ITEM	14
MANAGER'S REPORT NO.	4
COUNCIL MEETING	1978 01 16

Re: LETTER FROM BRITISH COLUMBIA HYDRO AND POWER AUTHORITY
WHICH APPEARED ON THE AGENDA FOR THE 1978 JANUARY 09
MEETING OF COUNCIL (Item 4a)
REQUEST FOR ENCLOSURE OF AN OPEN WATERCOURSE
GILMORE MAINTENANCE OVERHAUL CENTRE
LOTS 1 AND 2, BLOCKS G & H, D.L. 118, PLAN 3067

TO: MUNICIPAL MANAGER
FROM: DIRECTOR OF PLANNING
SUBJECT: REQUEST FOR STREAM ENCLOSURE - GILMORE MAINTENANCE OVERHAUL CENTRE - B. C. HYDRO AND POWER AUTHORITY
Lots 1 & 2, Blocks G & H, D.L. 118, Plan 3067

MASTERPLAN
SHOWING GILMORE MAINTENANCE AND
OVERHAUL CENTRE

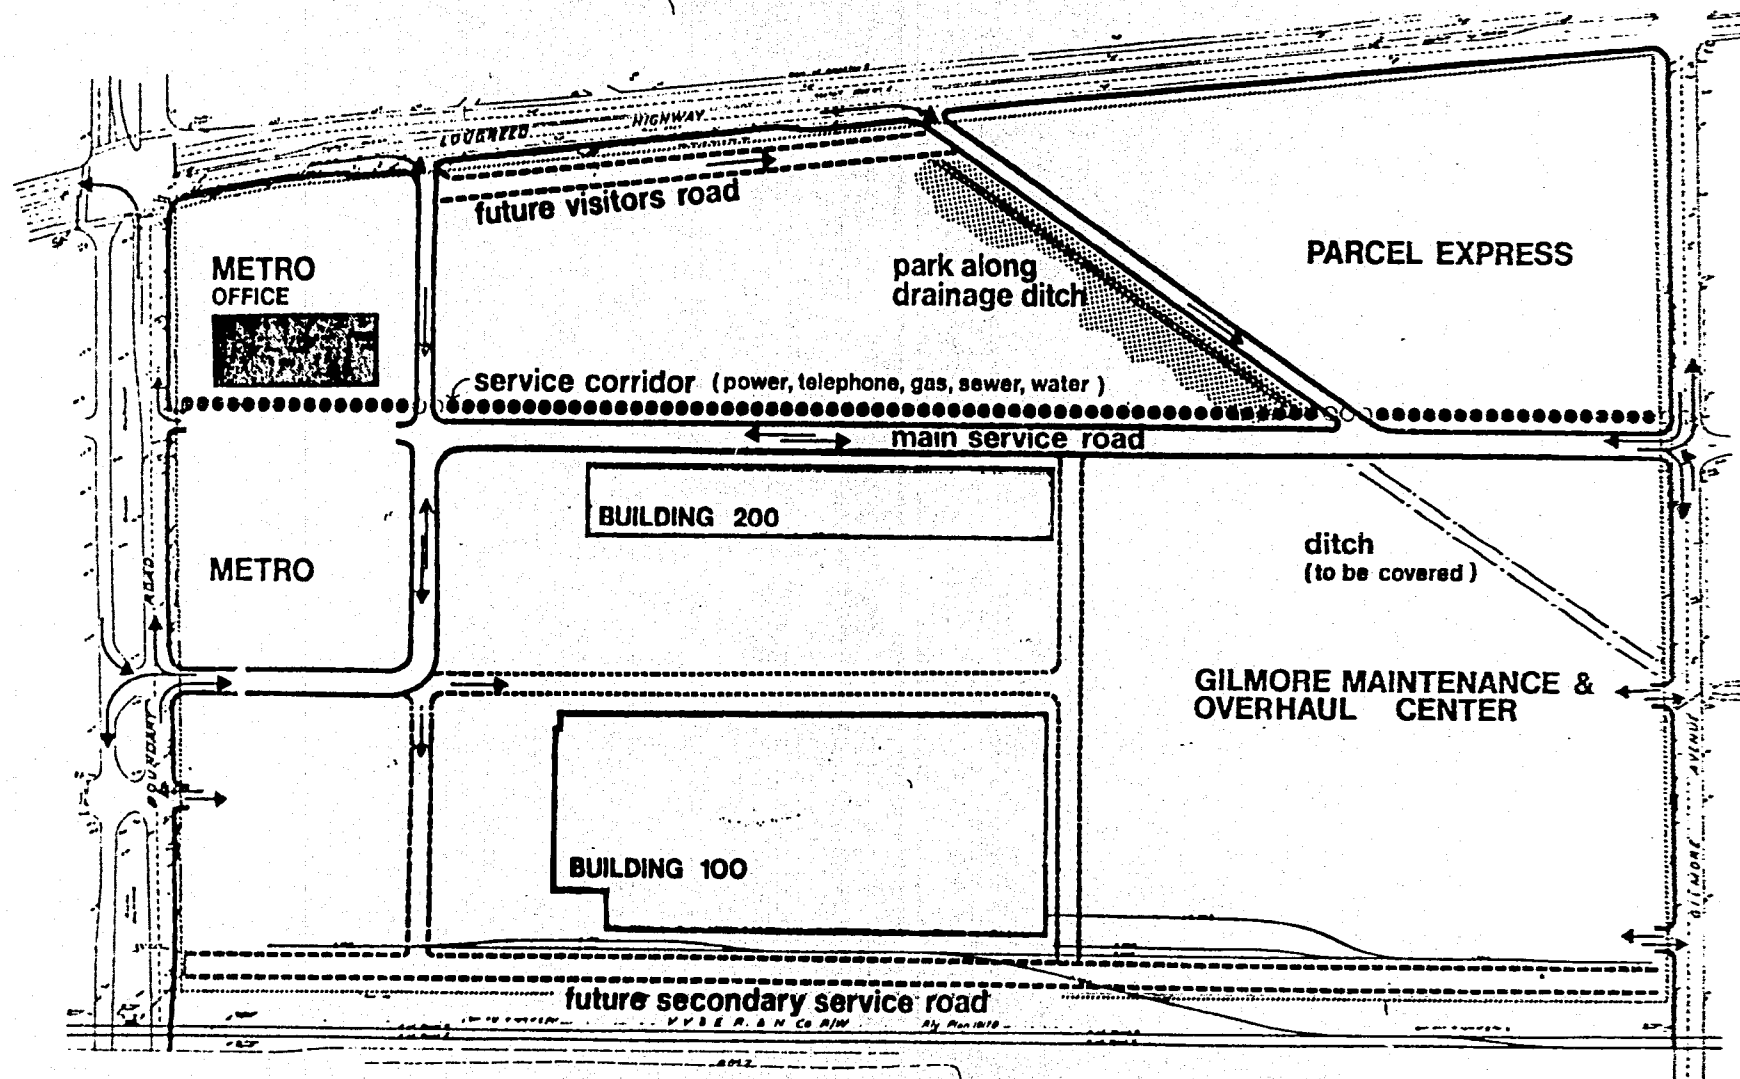
The portion of the waterway which is requested to be enclosed is shown on the attached sketch. This represents the southerly 183 m (600 feet) of the open watercourse lying within Hydro property; the remaining 198 m (650 feet) extending northward to the Lougheed Highway is intended to be preserved in an open condition with a landscaped treatment to create a park-like setting visible from the Lougheed Highway.

It is recommended THAT Council grant approval in principle to the enclosure of the referenced portion of the North Branch of the Still Creek system subject to the following:

- (a) Provision of inspection chambers in the detailed design, including chambers at any storm drainage outfalls from the development site to the enclosed portion of the stream,
- (b) Provision of suitably designed and maintained grease interceptors from all yard and shop area drains that discharge to the storm sewer,
- (c) Any washup areas for vehicles to discharge to the sanitary sewer system after treatment, and cover of any such areas to prevent the intrusion of storm water to the sanitary system; any process or cleanup areas where industrial cleaners or other contaminants may be involved, to discharge to the sanitary sewer after treatment satisfactory to the Health Department,
- (d) Engineering design approval to the satisfaction of the Greater Vancouver Sewerage and Drainage District,
- (e) Suitable landscape treatment of the covered area.
